Midal Cables International

Tomago Aluminium Rod and Cable Manufacturing Project

Submissions Response Report

April 2012

Figure 3 School Drive West Road Conditions (February 2011)

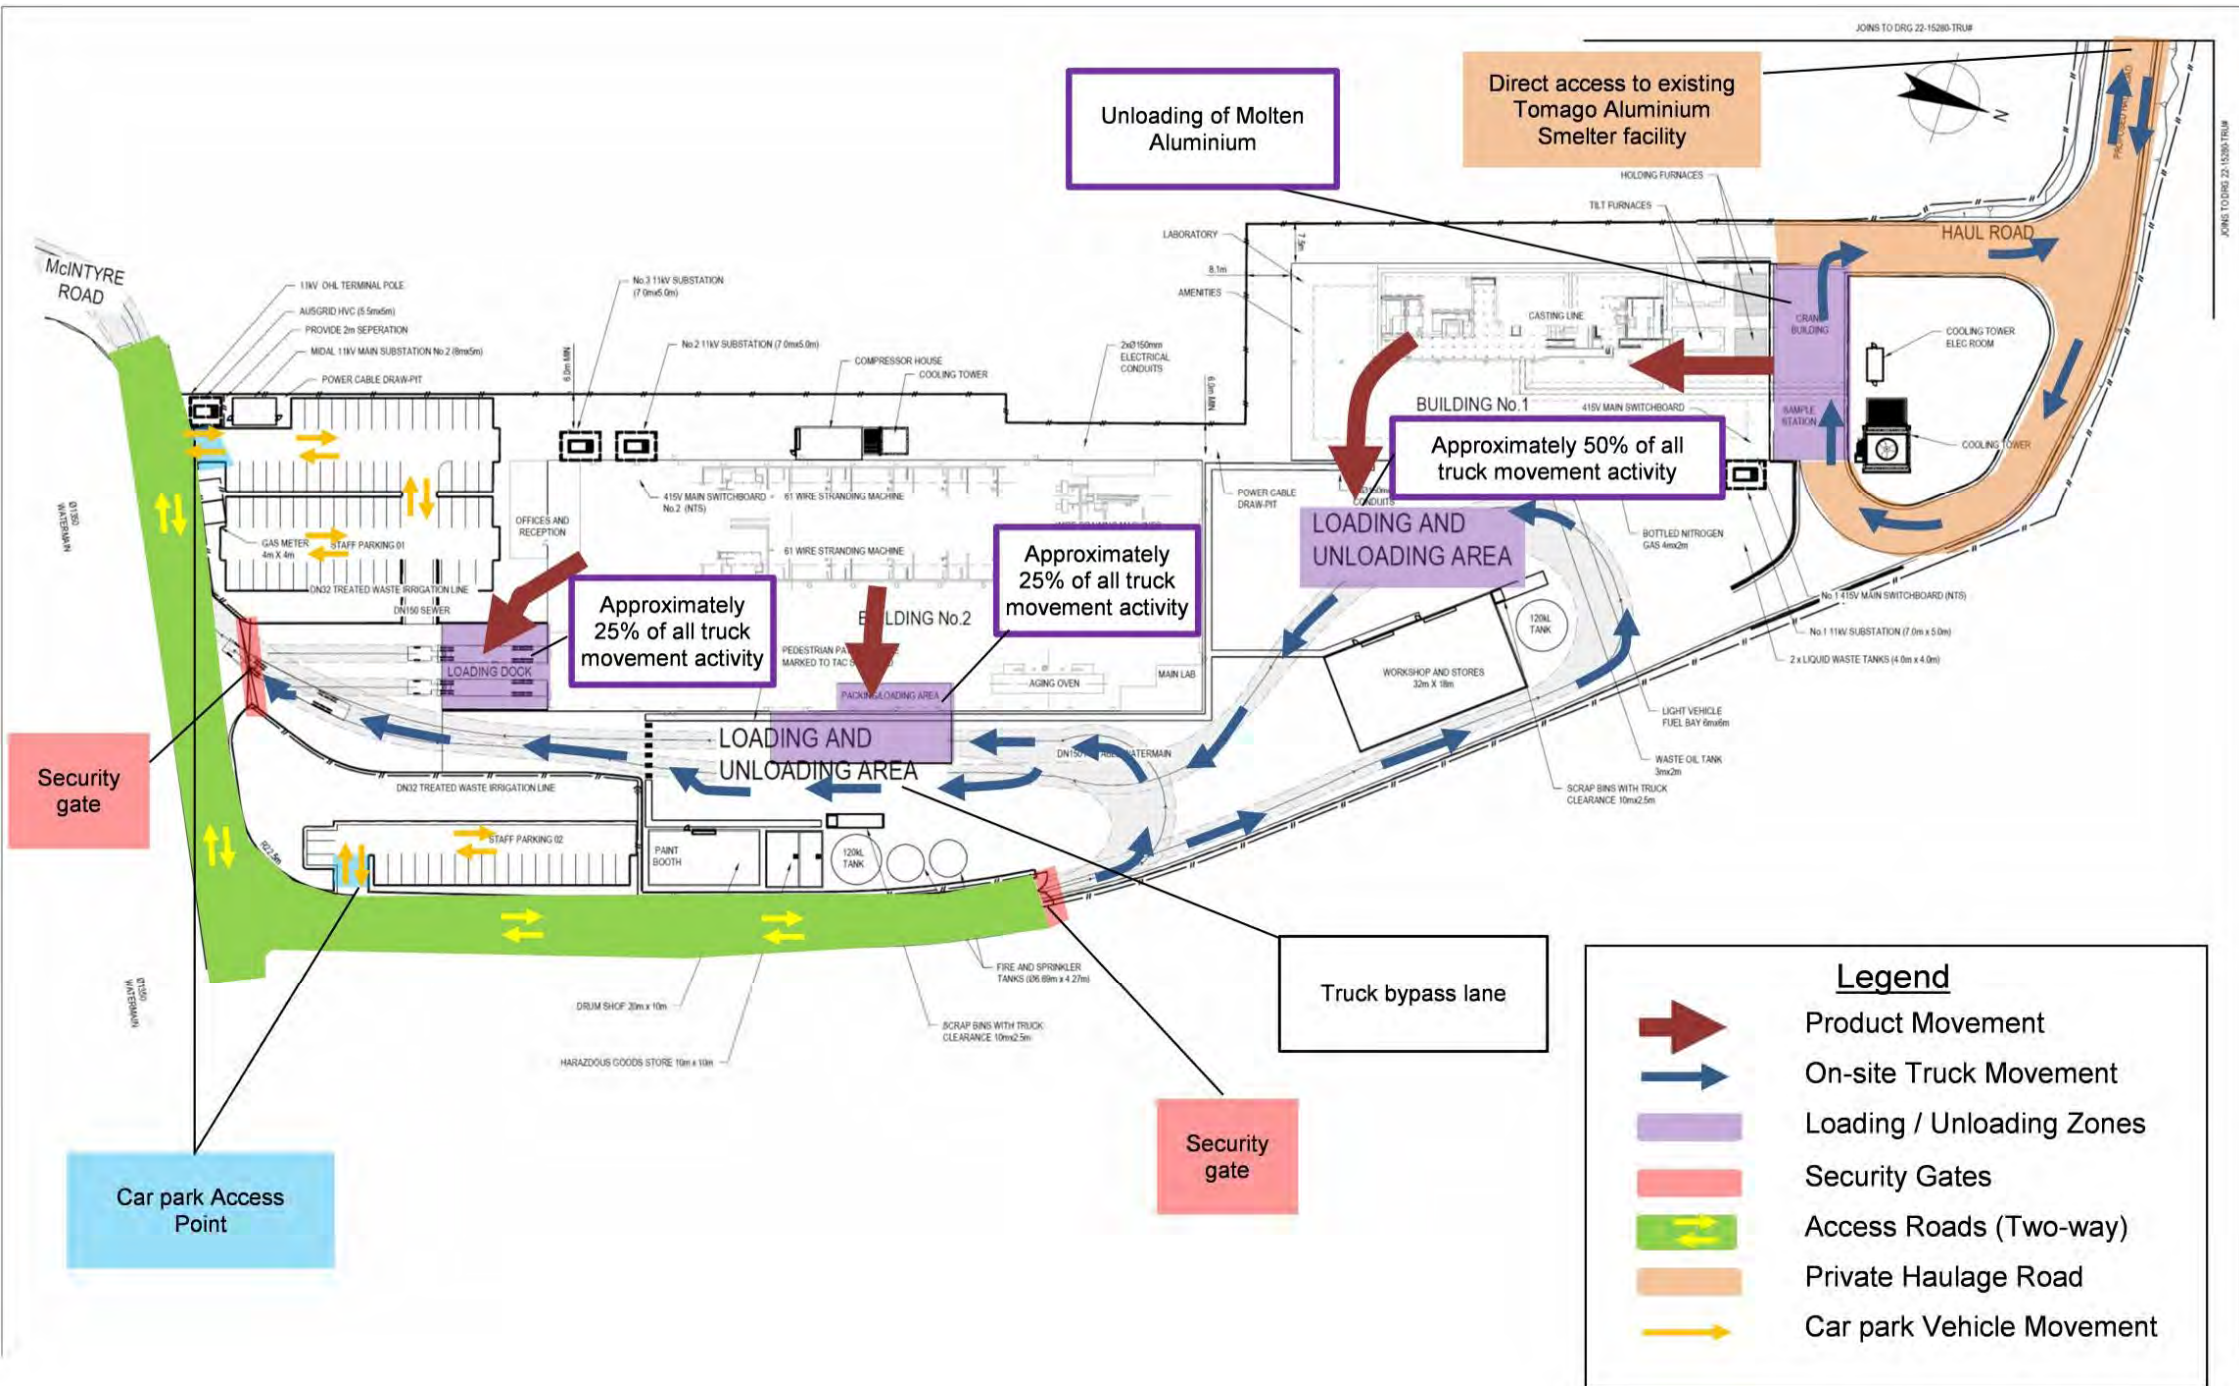
This submission supported the project but noted that School Drive and the associated intersections are in poor condition and should be upgraded to allow the project to proceed.

The Traffic Impact Assessment indicates that School Drive has a sealed two lane carriageway in a fair condition with wide grass shoulders. The submission advised that the western most 500m is mostly two lanes wide but it has lengths that are only 4m wide of sealed surface. The eastern most 500m of School Drive is only one lane wide and in many parts it has a semi-sealed surface.

Issue – The condition of School Road has deteriorated since the field inspection was undertaken for the traffic assessment

The traffic assessment summarises observations of a field inspection in March 2011, however this submission indicated that the condition of School Road has deteriorated since this time. Factors contributing to the deterioration include:

The site itself is expected to generate 18 heavy vehicles (movement of product and deliveries) and 124 light vehicles (shift workers, administration staff and contractors) along School Drive on a typical weekday. All heavy vehicles would be directed to use School Drive west and McIntyre Road to access the Tomago Road, which is the most suitable and appropriate route for transporting goods and materials to and from suppliers and end of use destinations that are accessed via the Pacific Highway.

The study undertaken for the Environmental Assessment acknowledged that some light vehicles, generated by staff accessing the site, may choose to use the eastern section of School Drive to travel to and from destinations to the east. This traffic flow is likely to be low and unlikely to be impacted by isolated narrow sections of road. The above distribution profile is both consistent with 2011 traffic conditions associated with existing industrial area operations and assumptions agreed with RMS.

Figure 3 provides an understanding of the traffic conditions along the western section of School Drive. Site observations at the time of the inspection indicated that the route was appropriate and suitable for traffic generated by the project, which only amounts to 18 heavy vehicles a day.

Road design standards

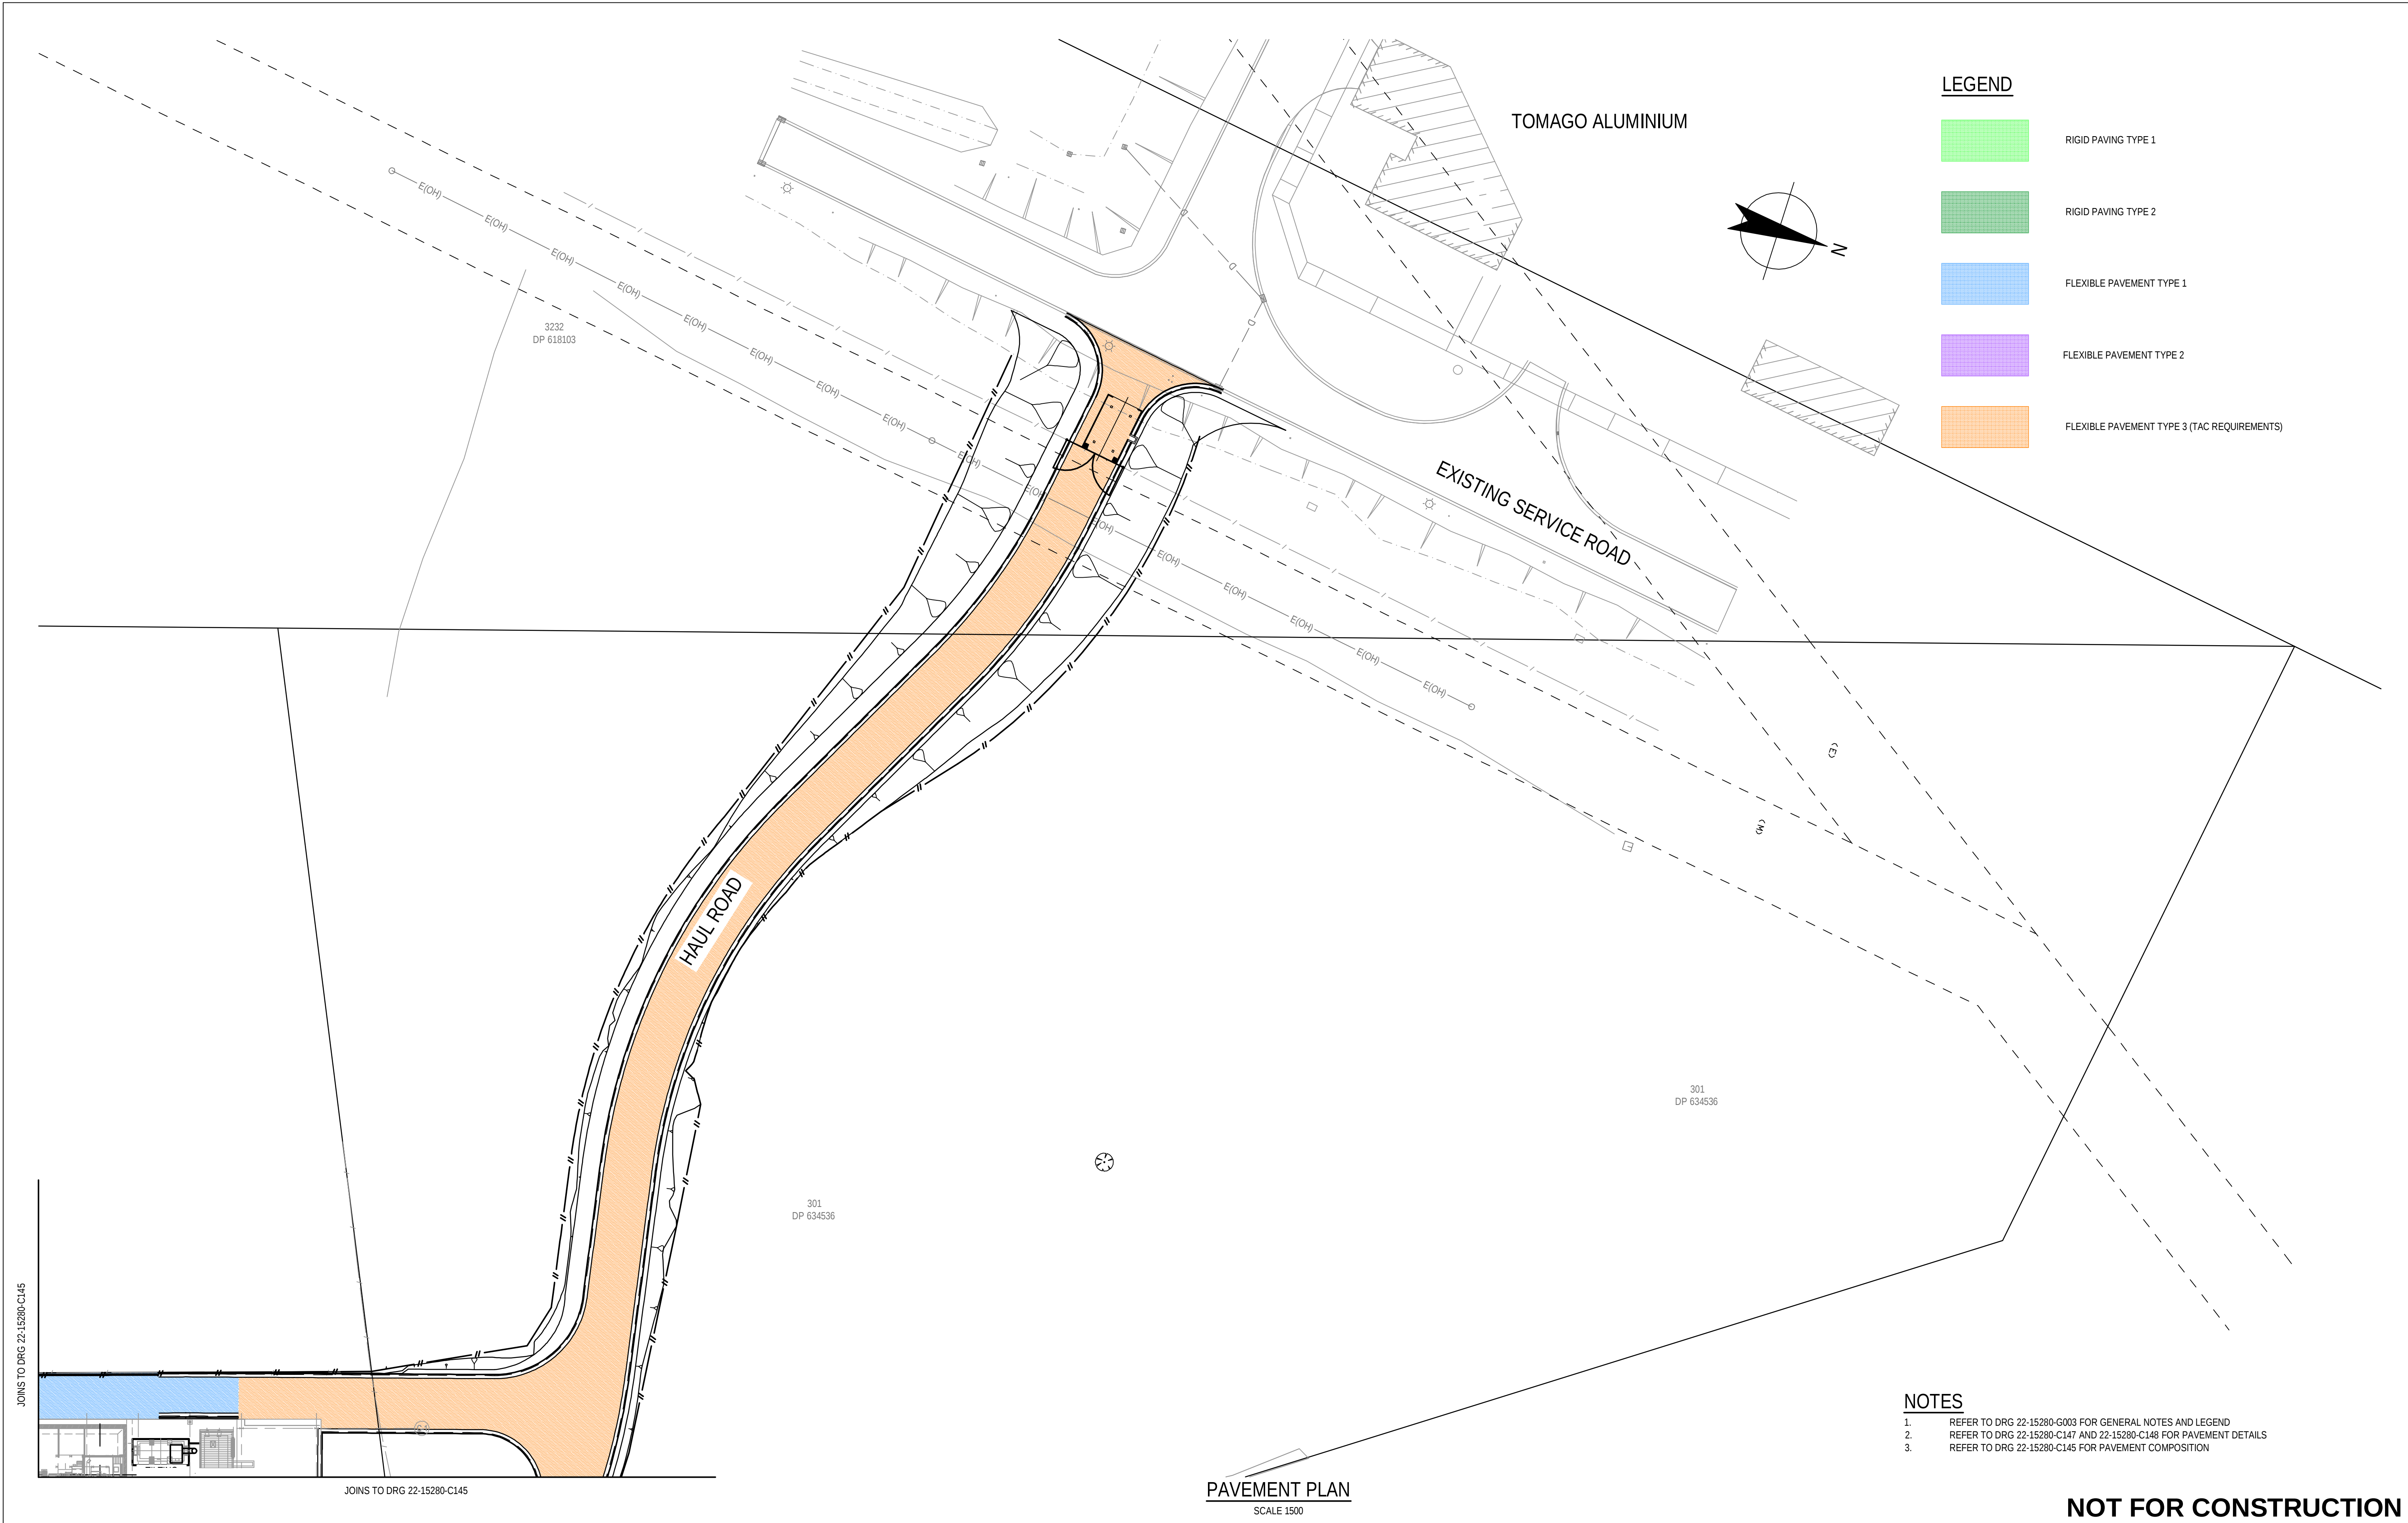
The Department would like to clarify the standards that Private Road and the site access would be designed to comply with.

The section of the private road and the site access would be upgraded to comply with Austroads guidelines for road geometry. Appendix B includes a figure showing the design standards that would apply to each section of the road network that would be constructed as part of the project. This indicates that Midal only proposes to upgrade the section of private road for the frontage of the site and the access road along the eastern boundary. No upgrades to McIntyre Road or School Drive are proposed.
